Description:Tender for Bhopal Rail Plant

Bid invitation number:6300040354

NAME OF THE WORK : : Engineering, Procurement & Construction pertaining to establishment of Rail coach factory including Civil Construction of manufacturing blocks, testing bay, other utility buildings (Non factory buildings), Railway Track sidings, water supply and distribution System, Roads, Drainage and sewerage systems, General Electric works including regular and emergency power supply and distribution system, related installations & services ( Fire, Gas, Compressed air, IT, BMS, etc.), MFA ( Miscellaneous fixed assets) and other Land & Site development works including grading, levelling works in connection with setting up of a Rail Coach Factory hereinafter referred as BEML RAIL HUB FOR ADVANCE MANUFACTURING (BRAHMA)near Umaria village, Obaidullaganj, District- Raisen, Madhya Pradesh (India) PIN code 464993 on EPC Mode.

Pre-bid Meetings – BEML Response to Pre-bid Queries from Bidders

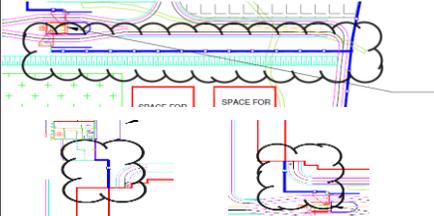
92	Drawings, Page 3 of 42	Master Plan Layout MEC-I0047-01-14-D1-ZZ-ZZZ-DR-J-10100	As per levels indicated in Masterplan, the railway track levels vary from 459.15 lv to 452.55 lv which is 6.60m level difference. Kindly validate the levels and confirm the main track levels at connection point of Main Line.	Please refer the revised master layout provided in Corrigendum-1
93	Drawings, Page 1 of 42	Sr. No. 24 & 25 - MRSS Building MEC-I0047-01-48-D1-XX-14-DR-A-01100 MEC-I0047-01-48-D1-XX-14-DR-A-01200	Both drawings are not available in the document, kindly provide	Revised set of drawings are provided in Corrigendum-1. Please refer.
94	Drawings	Inspection & Testing Building, Fabrication Building	As per tender Drawings, Toilet is not indicated in these two Buildings. Please provide locations to place the toilets requirement.	For manufacturing block, Washrooms have been proposed in office buildings annexed to it. There is no separate provision of washroom in inspection and testing bay. Refer Corrigendum-1.
